DEVELOPMENT APPLICATION NUMBER: 202544282**UNIT/S:****BLOCK/S: 54****SECTION/S: 10****SUBURB: RED HILL****DISTRICT: CANBERRA CENTRAL****REPRESENTOR 1:****COMMENT 1:**

Subject: Concern Regarding Non-Compliant Setbacks in Dual Occupancy Application – RZ1 Zone

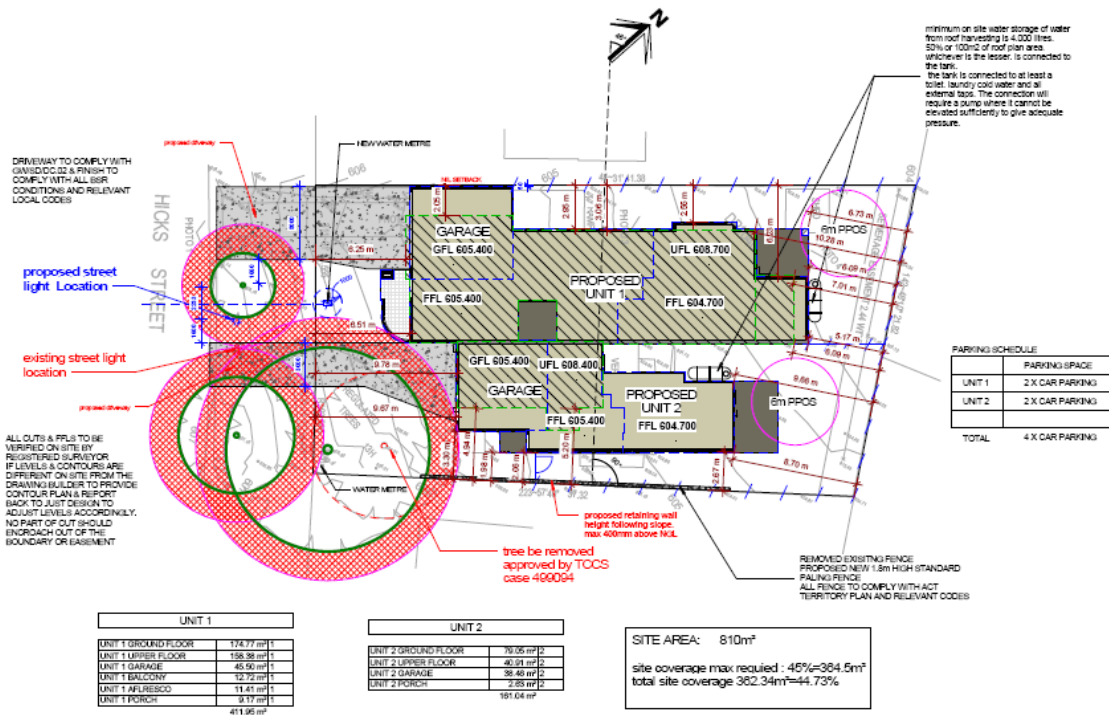
Dear Sir/Madam, I am writing in reference to the dual occupancy development proposal submitted for a residential suburban (RZ1) zoned block. According to the updated Territory Plan rules, side setbacks for dual occupancy dwellings are now required to be a minimum of 3 metres. Upon reviewing the site plan included in this application, I noticed that the proposed southern side setbacks are less than 2 metres—specifically 1.98 m, 2.06 m, and 2.67 m—which do not meet the current minimum requirement. Under the new rules, these figures represent a clear non-compliance with the 3-metre side setback standard. I would appreciate it if you could review the proposal in light of these updated regulations. Please let me know how this matter will be addressed moving forward. Thank you for your attention, and I look forward to hearing from you.
